IMAX REDEVELOPMENT – DEVELOPMENT NUMBER SSD 5397. 31 WHEAT ROAD, SYDNEY

**Assessment of proposed IMAX Redevelopment, Darling Harbour
The Ribbon, 31 Wheat Road, Sydney**

Application No. SSD- 5397

November 2013

2. Comparison of current IMAX vs IMAX proposal showing constriction of pedestrian flow

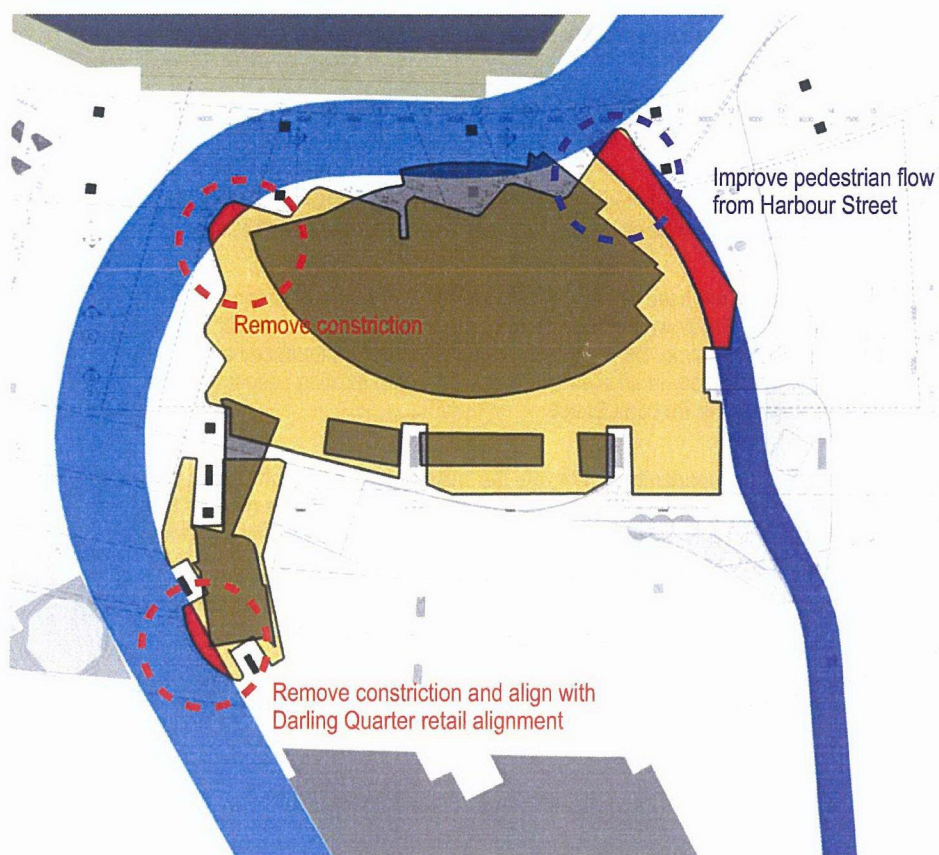
The IMAX redevelopment is an opportunity to complete the 'missing link' in the north-south pedestrian promenade from Haymarket to Barangaroo. The proposed development maintains much of this pedestrian circulation space but does appear to constrict north-south pedestrian flow in two areas.

There is also the question of continuous weather protection as described in the Urban Design Guidelines.

It appears however that modifications to the lower levels of the proposal would be relatively straightforward to address these issues.

5. Haymarket to Barangaroo promenade diagram showing constriction at proposed IMAX redevelopment

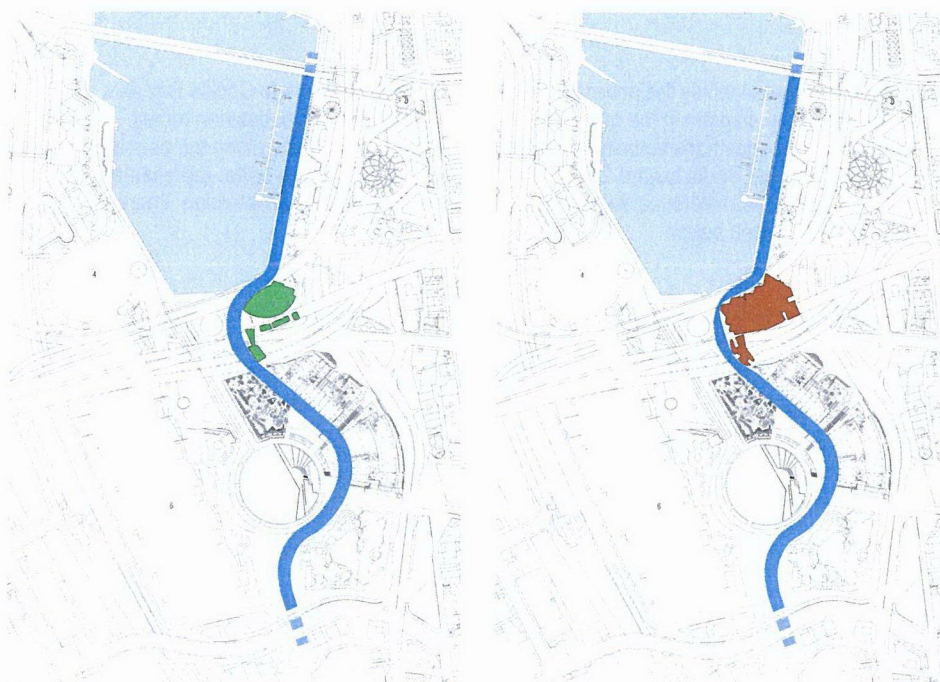
The proposal is located on a key site on this route and unnecessarily restricts pedestrian movement at this key point. Minor amendments to the footprint of the building would alleviate interruptions which disrupt the flow and legibility of this important pedestrian promenade and connection.

6. Public Domain level plan of proposed IMAX redevelopment showing non-continuous weather protection dotted over

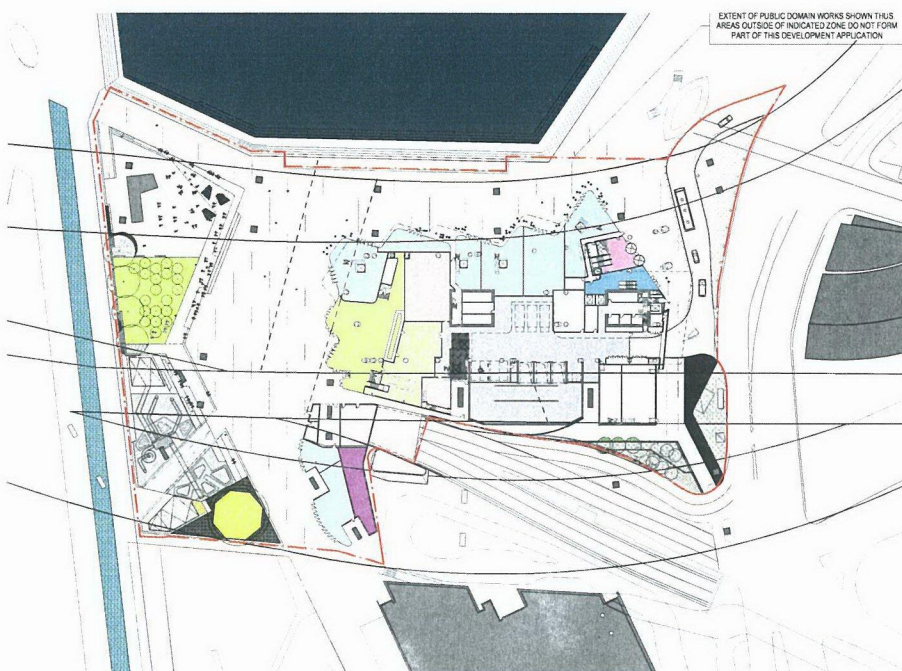
The proposal relies on the freeways over and the elevated building over for the majority of weather protection. Continuous protection at a height which will protect pedestrians is not provided.

Modification of the design to provide continuous weather protection and reinforce the continuation of the Darling Quarter precinct would be relatively straightforward.

7. Promenades diagram with the proposed IMAX redevelopment plotted.

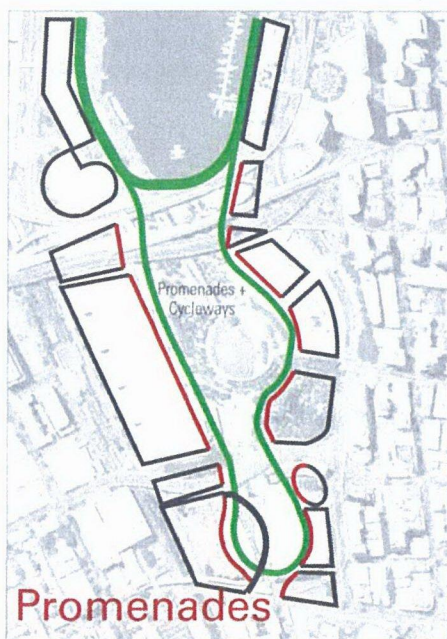
The proposed development interrupts the flow of promenades between Darling Harbour South and the waterfront

8. Diagram showing existing and proposed accessible public open space

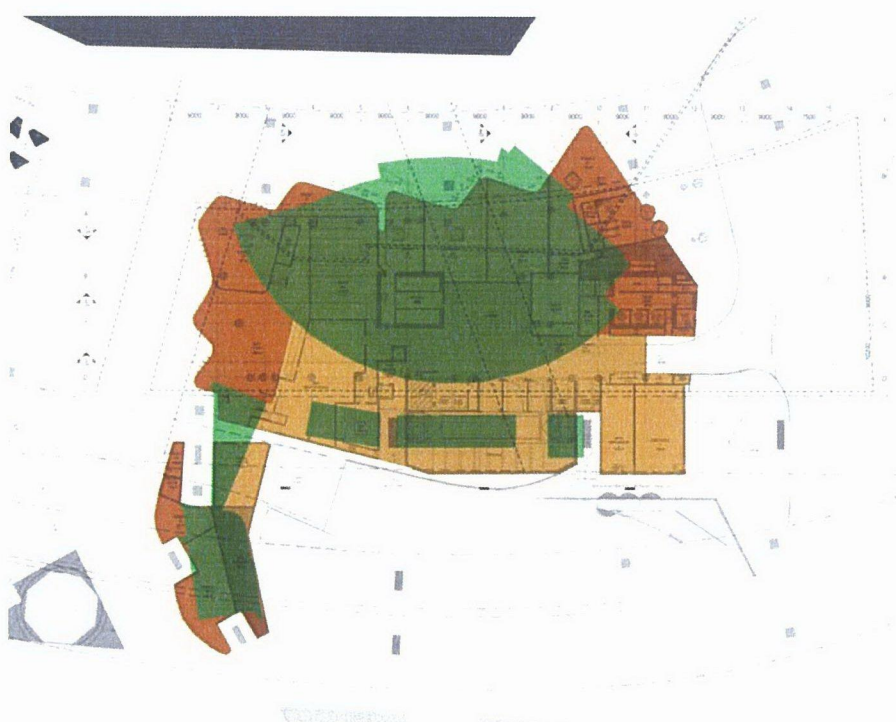
Accessible public open space in the vicinity of the IMAX redevelopment is proposed to be reduced by approximately 830m². This reduction in open space will not only reduce the pedestrian capacity of this key part of Darling Harbour, but constricts the pedestrian connectivity both in the north-south promenade direction and the east-west city link direction.

Modifications to the lower levels of the proposal would be relatively straightforward to address these issues as outlined in the north-south pedestrian connections and City/Darling Harbour connectivity sections of this report.

10. Facade reflectivity table from the Cundall reflectivity study

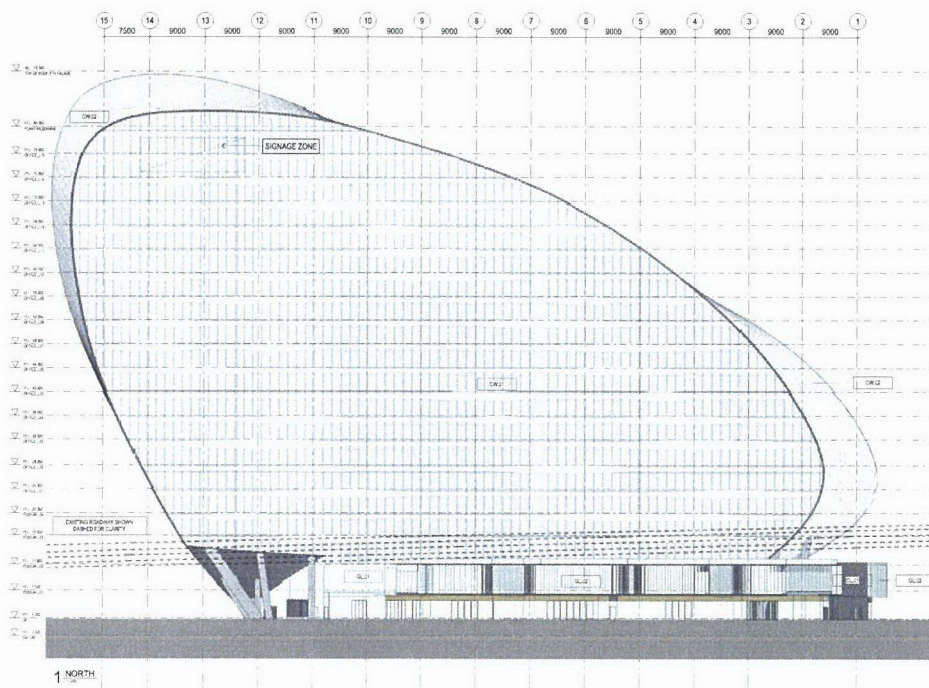
The reflectivity report requires the north glazing to have a maximum visible light reflectivity of 8% achieved via a glazing reflectivity of 15% and the application of vertical shading/baffle elements. The effect of this treatment is however not illustrated in the perspectives and plans submitted. In our opinion these devices will form a significant feature on the facade.

11. North elevation of the proposed development

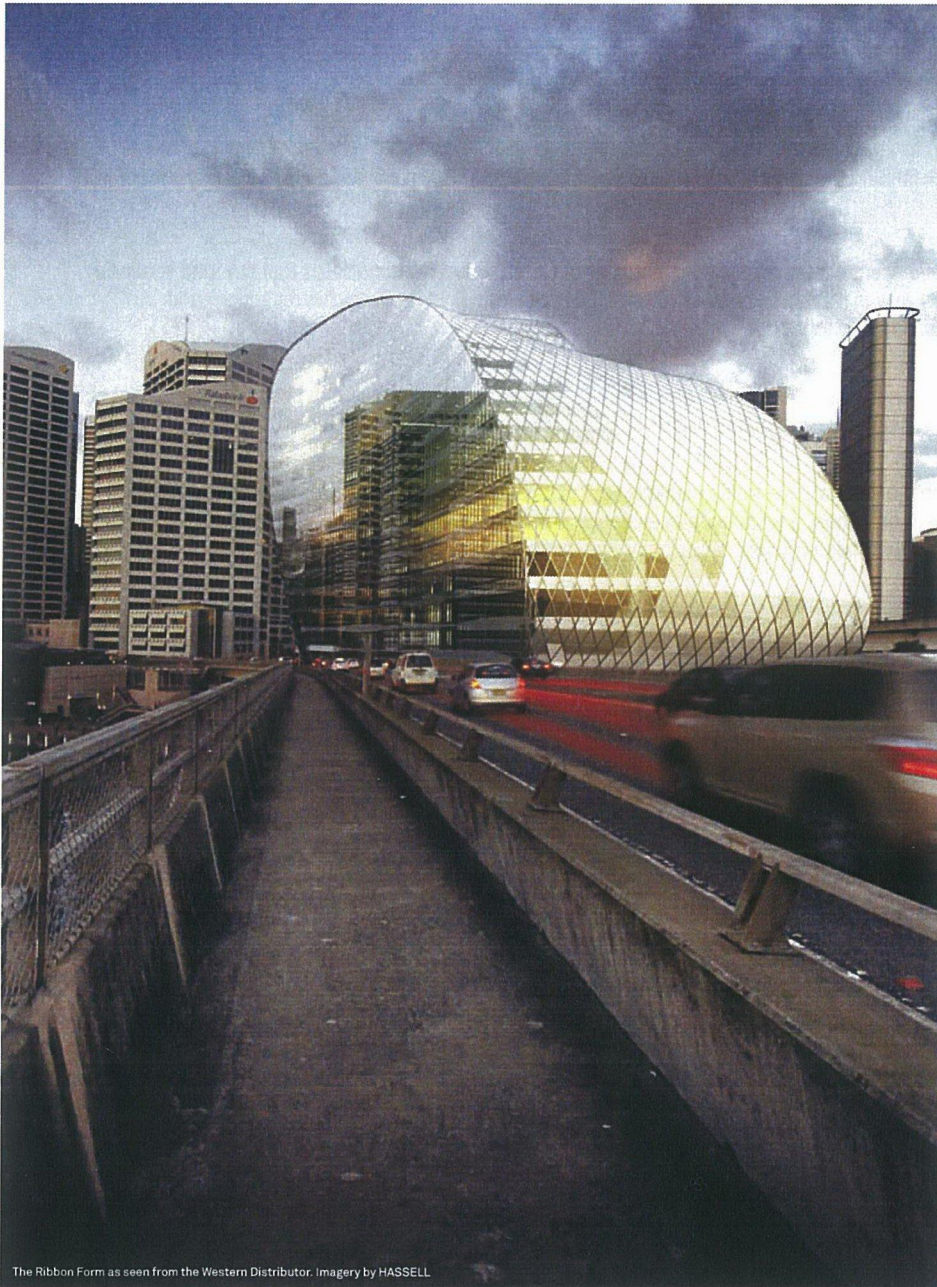
The appearance of the north facade is highly significant given the argument that the north face of the building is intended as an iconic addition to Darling Harbour and will be highly visible from Darling Park and Cockle Bay Wharf.

14. View of proposed development from Pyrmont Bridge

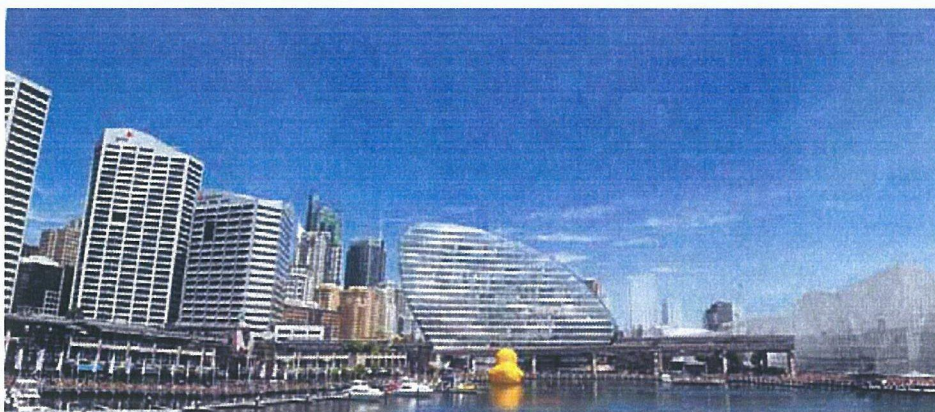
The proposed building is taller than the existing IMAX building and extends further west. This creates a visual barrier between the Cockle Bay/Waterfront and Parkland portions of the Darling Harbour precinct.

15. Comparative height and massing diagrams showing the proposed IMAX redevelopment

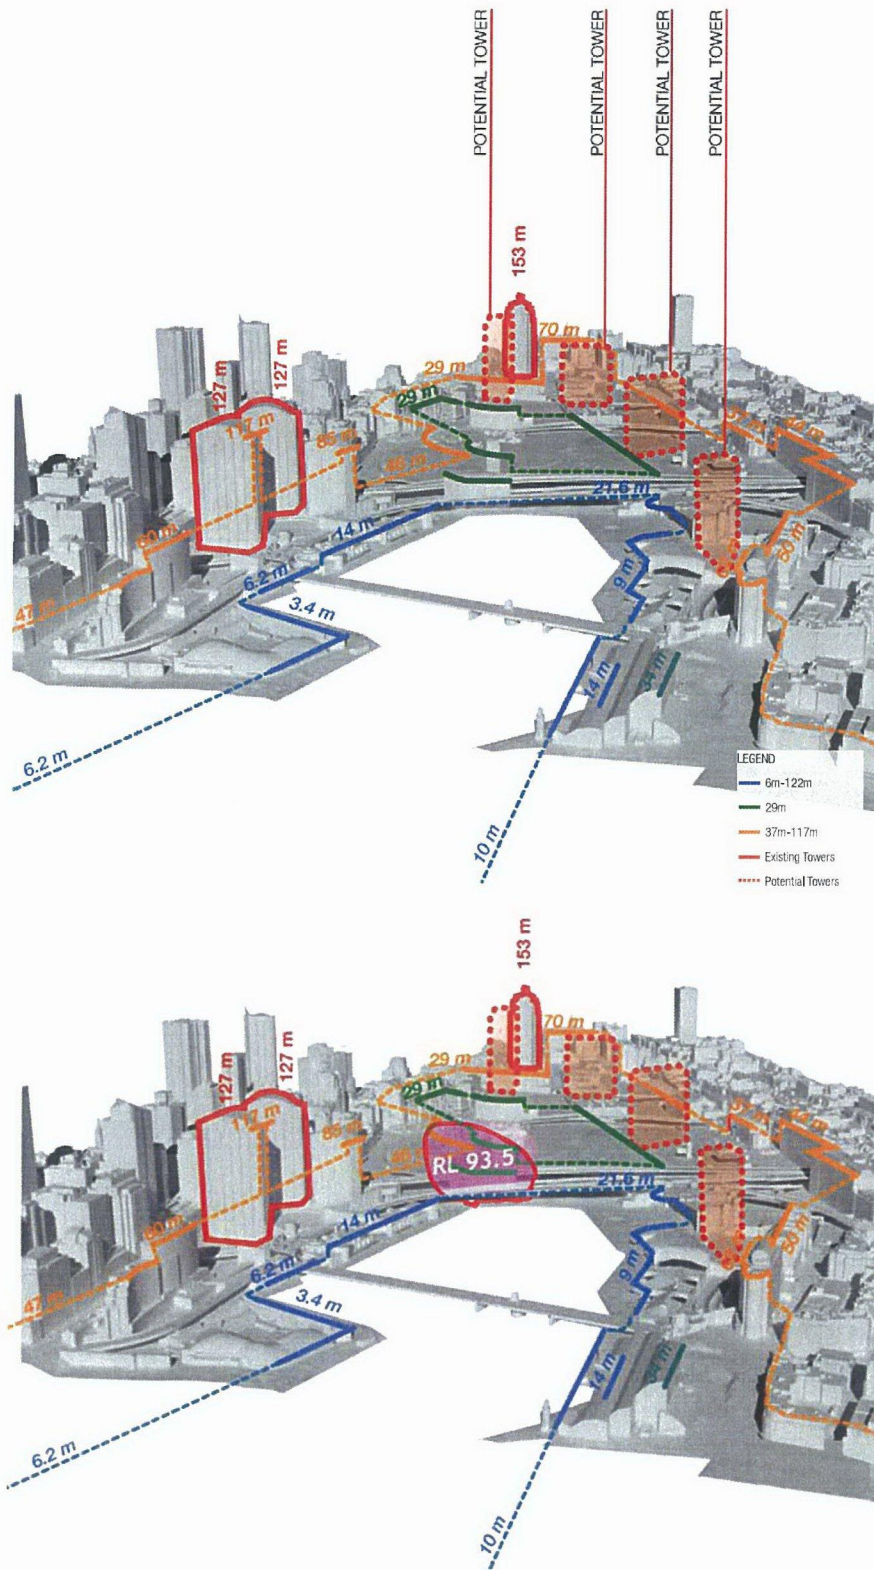
The proposed development breaks down the ‘valley floor’ concept to create a projection into the centre of Darling Harbour which visually divides the park from the harbour within the Darling harbour Precinct

16. Amended rendering of IMAX Redevelopment height and massing diagram

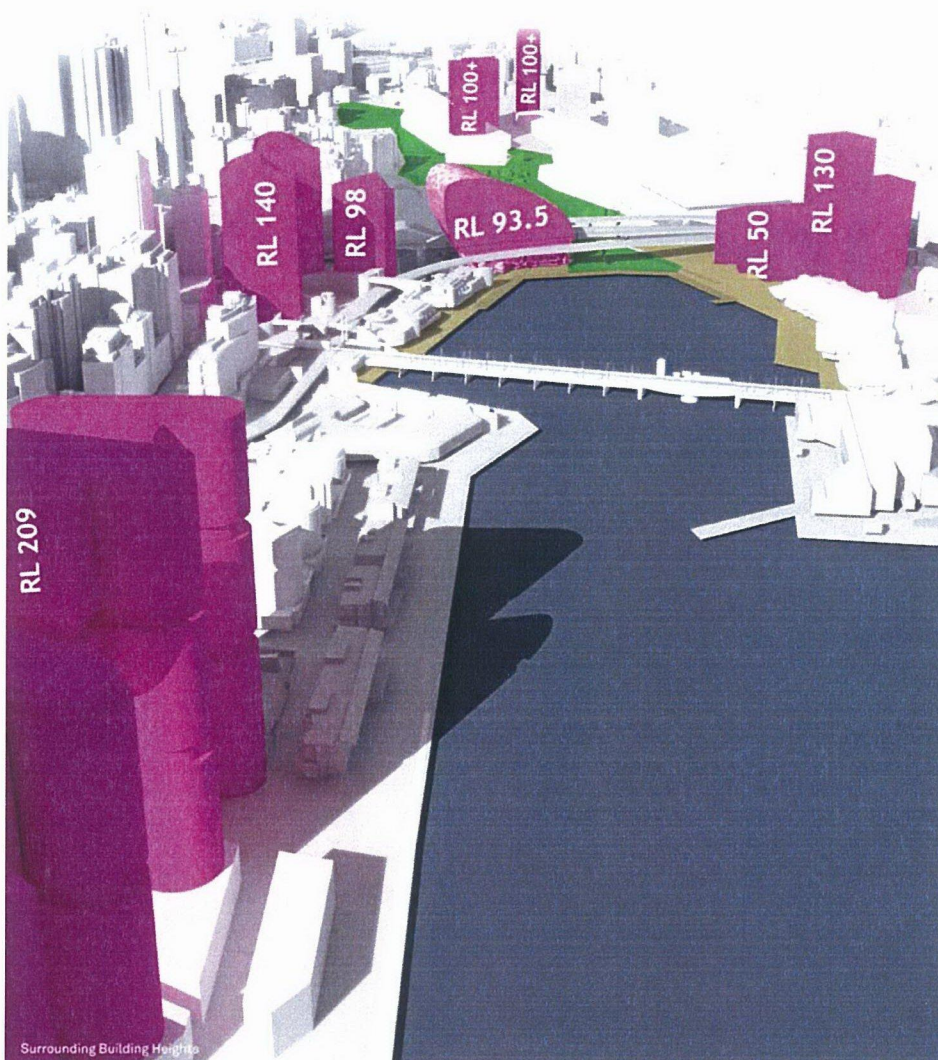
The Urban Design Report forming part of the submission provides an alternative height and massing diagram which we find the rendering of misleading. We have amended the rendering to remove the highlighting from Darling Quarter and highlight the full volume of the proposed IMAX development. We have also highlighted the foreshore and the park portions of Darling Harbour.

This amended rendering shows the visual division of Darling harbour resulting from the proposed development.

17. Cross section of Darling Harbour showing the increase in height and scale of the proposed IMAX redevelopment

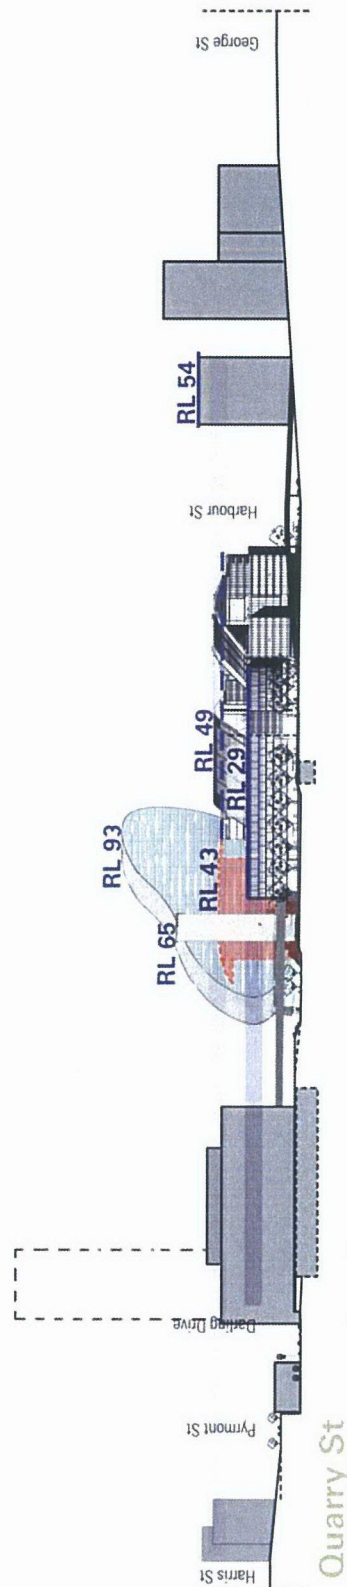
The cross sections of Darling Harbour on the following page illustrate the increase in height and scale of the proposed IMAX redevelopment and disjuncture with the scale of other buildings surrounding the precinct.

18. Diagram showing the extent of additional overshadowing of the children's playground at 11am at mid-winter (approximately 19% reduction in sunlit area)

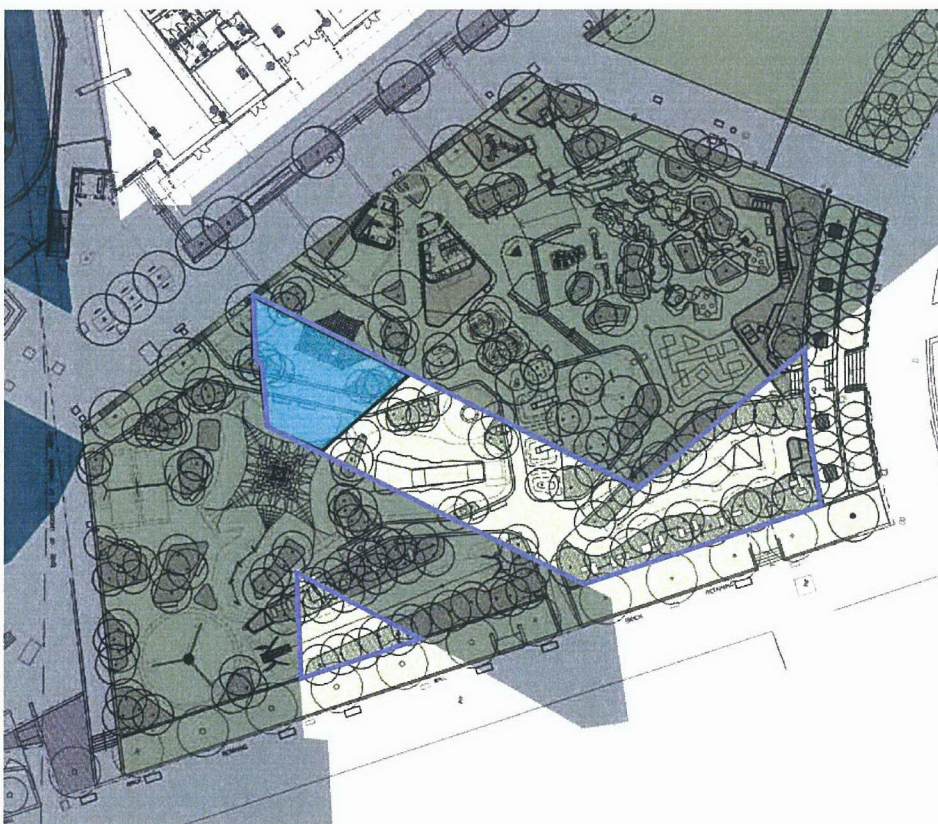
The proposed IMAX redevelopment creates additional overshadowing on the children's playground on winter mornings, a key time when sunlight is important for children's play. Key concerns regarding the overshadowing of the playground are:

- (a) There is an approximately 19% reduction in sunlit area of the playground in mid winter at 11:00am.
- (b) Shadow diagrams illustrating the reduction in sunlit space in the playground for the full morning period in winter and between winter and the Spring and Autumn periods have not been provided

Any additional overshadowing of the children's playground in winter is a highly undesirable outcome for Darling Harbour and the community and is not in the public interest.
